Dart Aerospace Ltd.

Drawing Name: X-TUBE SUPPORT CHANGE

DESIGN <i>PH</i>	DRAWN BY <i>PH</i>	<b>DART AEROSPACE LTD</b> HAWKESBURY, ONTARIO, CANADA	
CHECKED <i>[Signature]</i>	APPROVED <i>[Signature]</i>	DRAWING NO. DSI 9366	REV. A SHEET 1 OF 2
DATE 07.02.07		TITLE CROSSTUBE SUPPORT CHANGE SCALE NTS	
A	07.02.07	NEW ISSUE

TO AMEND INSTALLATION INSTRUCTIONS IIN-D206-667 Rev. C AND  
INSTRUCTIONS FOR CONTINUED AIRWORTHINESS ICA-D206-667 Rev. 2  
REF. CANADIAN STC: SH01-5  
REF. FAA STC: SR01304NY

**FIGURE 1 - CROSSTUBE SUPPORT  
INSTALLATION ON D407-667-205**

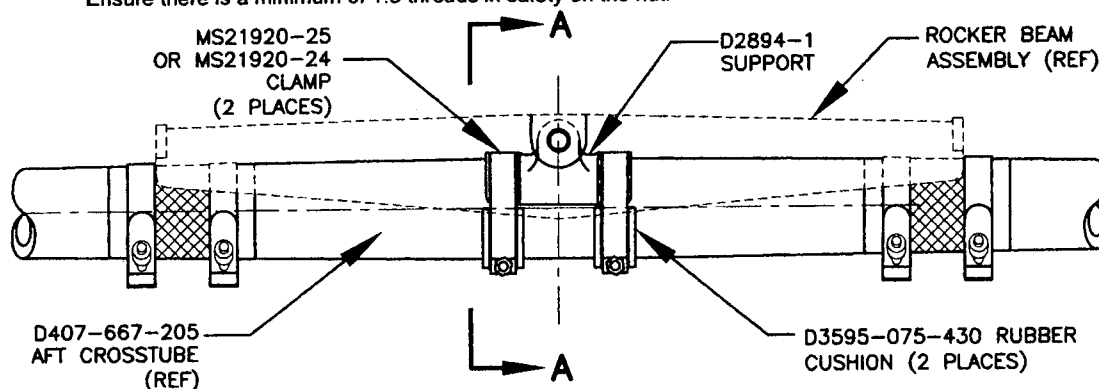
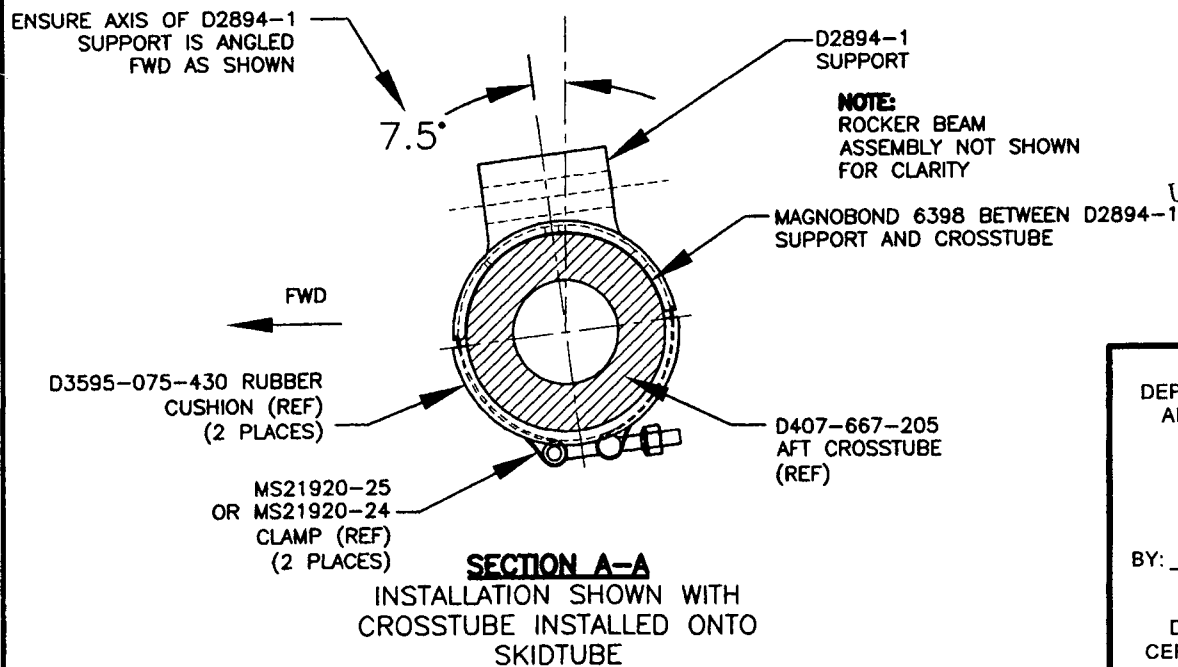
For D407-667-205 Aft Crosstubes at CHG 004 or later, the D2856-600-851 Abrasion Strip has been removed, the center D2894-1 Support has been bonded onto the crosstubes using Magnobond 6398 and D3595-075-430 Rubber Cushions have been installed underneath the MS21920-24/-25 Clamps. Amend Parts List of IIN-D206-667 Section 5 and ICA-D206-667 Section 32.8 as follows:

To prevent the center support from shifting on D407-667-205 Crosstubes at CHG 003 or earlier, the D2894-1 Support should be removed and re-installed as follows:

- 6) Apply a 0.03" to 0.06" thick layer of Magnobond 6398 underneath D2894-1 Support and re-install the Support on the crosstube as shown in Figure 1. Use rocker beam assembly to properly align the D2894-1 Support. Ensure the Rocker Beam Assembly can move freely without any friction with other parts. Position and secure the D2894-1 Support on the crosstube using MS21920-24/-25 Clamps. Install a D3595-075-430 Rubber Cushion underneath each MS21920-24/-25 Clamp. Torque clamps 80-100 in-lb. Let the D407-667-205 Crosstube Assembly cure before re-installing the crosstube on the aircraft.
